PNP 2014-010

SUBJECT: Palisades Nuclear Plant Second Six-Month Status Report in Response to March 12, 2012 Commission Order Modifying Licenses with Regard to Reliable Spent Fuel Pool Instrumentation (Order Number EA-12-051)

Palisades Nuclear Plant  
Docket No. 50-255  
License No. DPR-20

# **Palisades Nuclear Plant Second Six-Month Status Report in Response to March 12, 2012 Commission Order Modifying Licenses with Regard to Reliable Spent Fuel Pool Instrumentation (Order Number EA-12-051)**

Figure 1: SFP Area Plan View

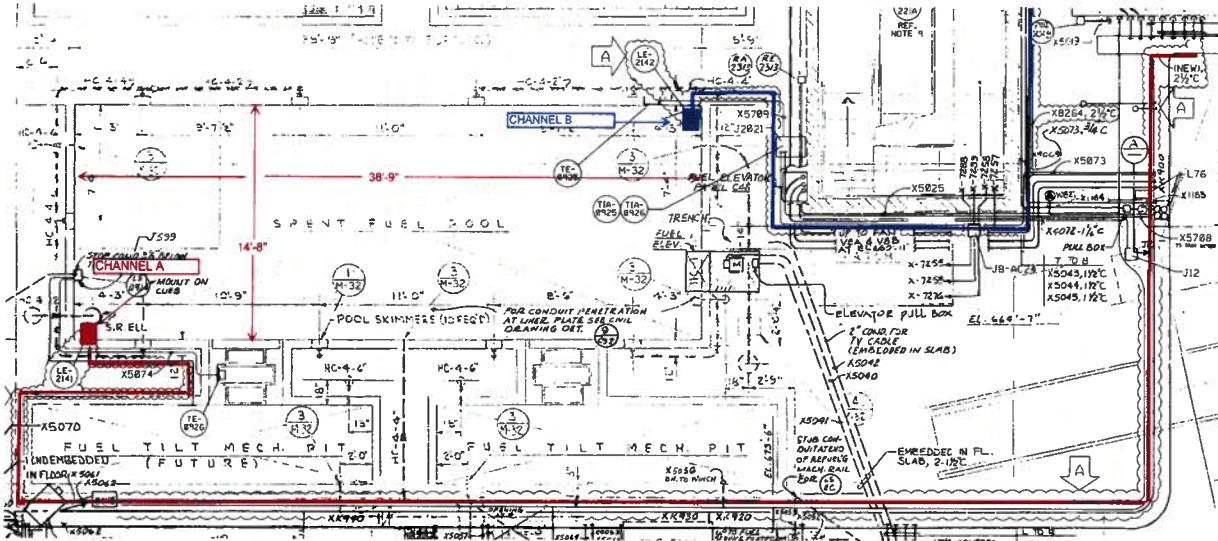
Attachment 1 of the Overall Integrated Plan (Reference 1) shows Channel A mounted against the north wall near the northwest corner of the Spent Fuel Pool (SFP). The location of Channel A has been moved to the west wall near the northwest corner of the SFP. See Section 7 for additional discussion. Section 7 also contains a figure with the new cable routing for the SFP area.

Section 3.4 of the Interim Staff Evaluation discusses the arrangement of the SFPI channels and references the sketch in Attachment 1 of the Overall Integrated Plan. As discussed in Section 4, the location of the Channel A level instrument has been moved to the west SFP wall, within 12" of the northwest SFP corner. The updated sketch of the SFPI arrangement showing the new cable routing is provided below in Figure 1.

Section 3.4 of the Interim Staff Evaluation also refers to a statement that declares cables in the SFP area will be routed in seismically mounted rigid metal conduit. It should be noted that this statement does not apply to the first 20 ft. of cable run, which is comprised of SiO<sub>2</sub> stainless steel armored cable. The SiO<sub>2</sub> stainless steel armored cable then transitions to coaxial cable, at which point the coaxial cable will be installed in seismically mounted rigid metal conduit for the remainder of the run in the SFP area. This cable installation is applicable to both Channel A and Channel B.
